# #01-02-35-008: Electronic Steering Column Lock May Refuse to Operate - DIC Service Message Displayed (Update Column Lock Wiring, Install Revised Relay and/or Replace Electronic Column Lock) - (Dec 3, 2001)

**Models:** 1997-1998 Chevrolet Corvette

2000 Chevrolet Corvette

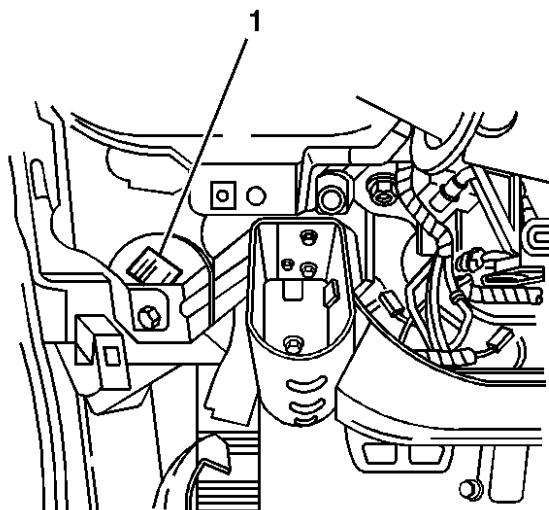
12. Remove and discard the Steering Column Lock/Cam Orientation plate using the J 38364.
13. Install the included Cam Orientation Plate and secure with a new locking ring, using J 42137 and J 38364 as shown.
14. Install the SIR coil and secure with snap ring.
15. Disconnect the connector from the ECL (located on the right lower side of the steering column) to the I/P main harness.

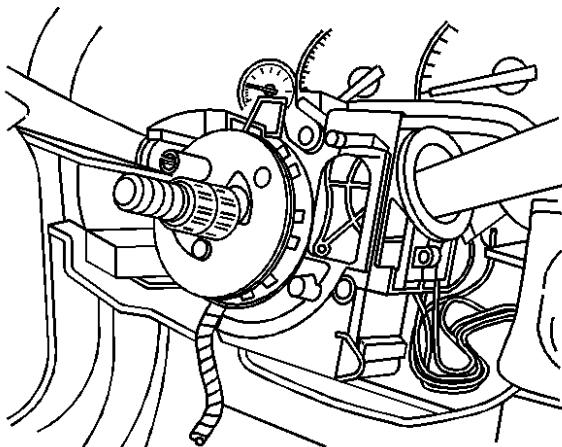
16. Route the new jumper wire and relay harness over the knee bolster (styrofoam and metal construction). The new relay (1) must be mounted to the left I/P brace with a zip tie as shown.
17. Install the new relay and jumper harness. Plug one end of the jumper harness into the connector on the I/P harness side. Plug the other end into the connector on the ECL side. The connectors on the jumper are specific and cannot be connected incorrectly. The connector becomes J165/P165.
18. Install the lower and upper steering column shrouds.
19. Install the wiper control stalk.
20. Install the tilt steering lever.
21. Install the steering wheel to the steering column.
22. Install a new steering wheel set nut, P/N 26056108.

**1997 and 1998 (early) Manual (U.S. & Canada and All Export (Manual & Auto)**

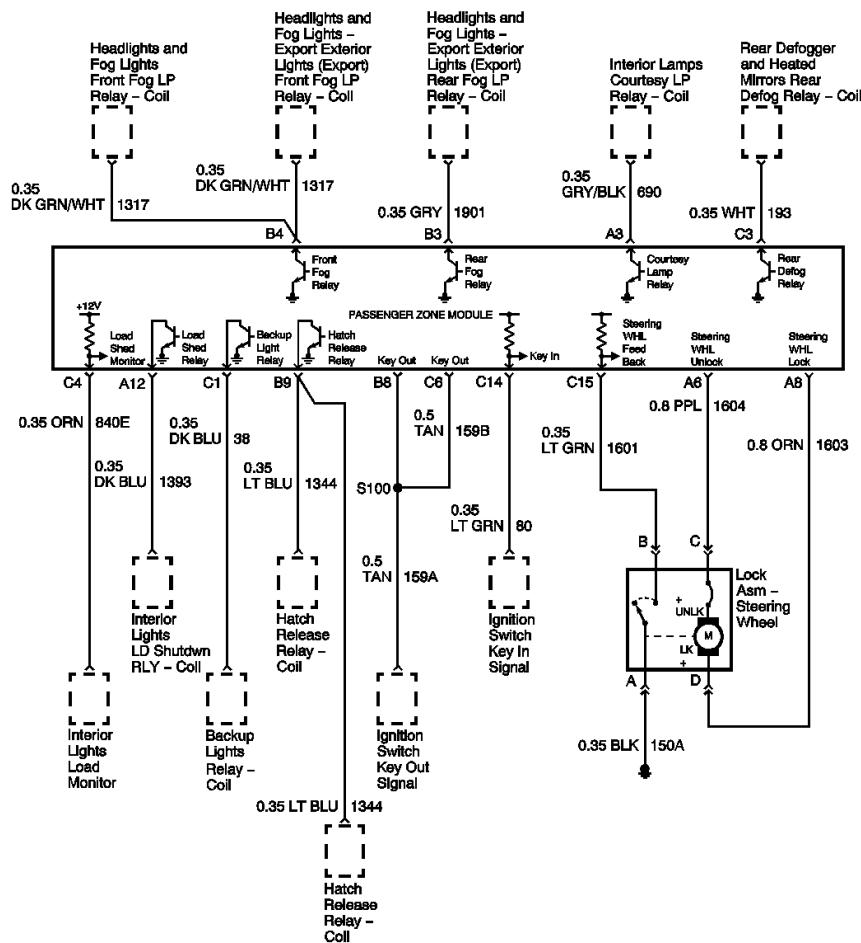
- In order to complete the wiring upgrades listed in the section, you will need to order P/N 88952428, Wire Kit, Strg Wheel Theft Dtrnt.
- You may use the included schematics to aid in verifying the installation of the new relay and jumper wire.

## 1997 and 1998 (early) Automatic (U.S. & Canada)

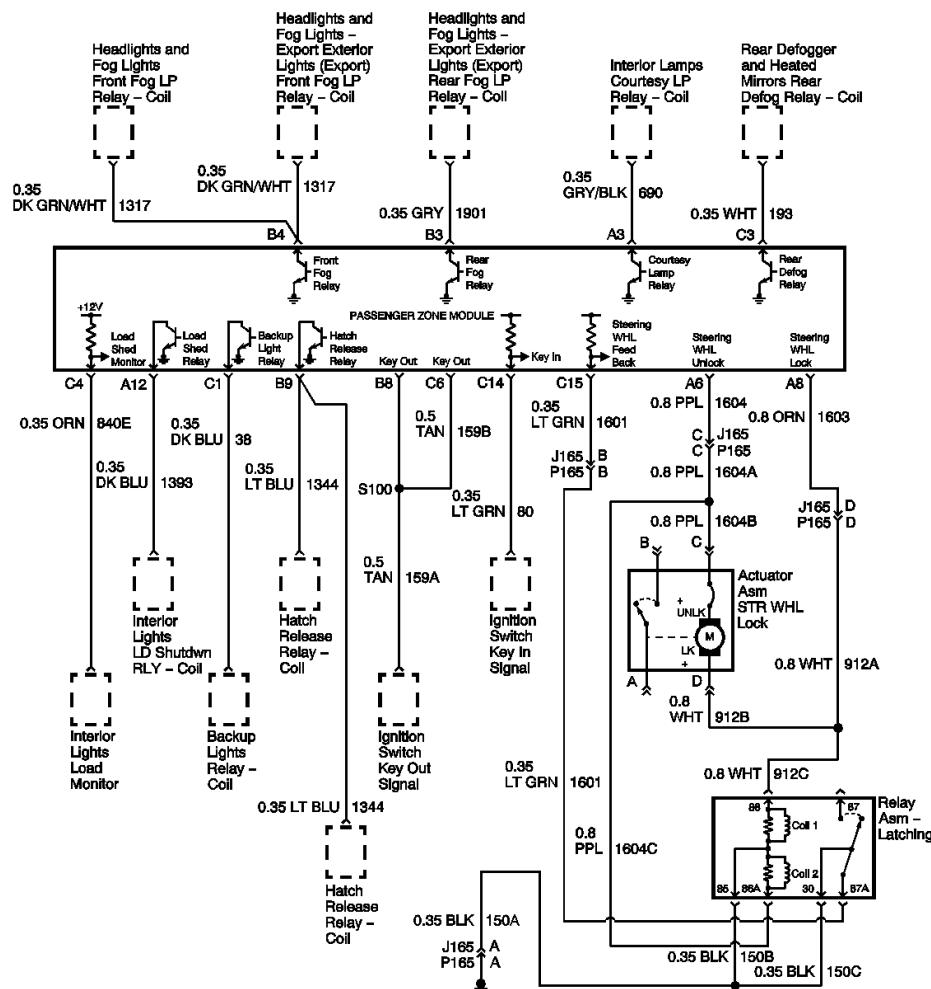
- When removing the driver's side knee bolster trim panel as described below, care must be taken not to damage the console trim plate as the knee bolster trim panel tucks in behind the console trim plate.
- Revised schematics are included to aid and/or verify the proper installation of the service kit.
